UNITED STATES PATENT AND TRADEMARK OFFICE

APPLICATION NO.	FILING DATE	FIRST NAMED INVENTOR	ATTORNEY DOCKET NO.	CONFIRMATION NO.
10/823,779	04/14/2004	Kyung-Kyu Kang	8733.1001.00	4667
30827	7590	08/23/2005		
MCKENNA LONG & ALDRIDGE LLP 1900 K STREET, NW WASHINGTON, DC 20006				
			EXAMINER CHOWDHURY, TARIFUR RASHID	
			ART UNIT 2871	PAPER NUMBER

Office Action Summary

DETAILED ACTION

Fig. 7

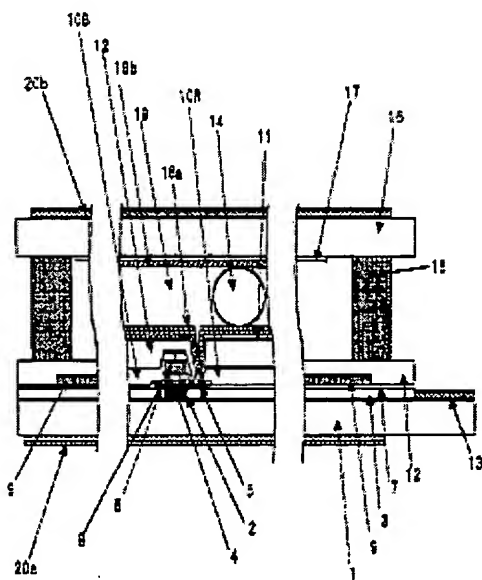
8. Okamoto discloses and shows in Fig. 7, a liquid crystal display panel, comprising:

- a black matrix (9) formed of a resin material (col. 4, lines 15-18), at a predetermined region of a first substrate (1) and at a boundary region of pixels;
- a color filter (10) on the black matrix corresponding to the pixels;
- an overcoat layer (12) on the first substrate having the black matrix and the color filter;
- an (11) made of ITO on the overcoat layer;
- a seal pattern (15) on the overcoat layer; and
- a second substrate (16) attached to the first substrate by the seal pattern.

disclose that the thickness of the over coat layer is between approximately about 1.2 micro-meters and about 5 micro-meters.

Therefore, it would have been obvious to one of ordinary skill in the art at the time of the invention was made to modify the display panel of Okamoto by employing an overcoat layer with an overcoat layer that has a thickness in the range of 1.0 – 3.0 micro-meters for advantages such as preventing impurities in the color filter from spreading into the liquid crystal and thus obtaining with excellent liquid crystal orientation characteristics.

As to claims 2 and 12, Okamoto shows in Fig. 7, that the black matrix (9) is extended at least from the seal pattern formed region to one end of the portion of the first substrate.

As to claims 10 and 21, it is clear from Fig. 7 that the black matrix partially overlaps the seal member (15).
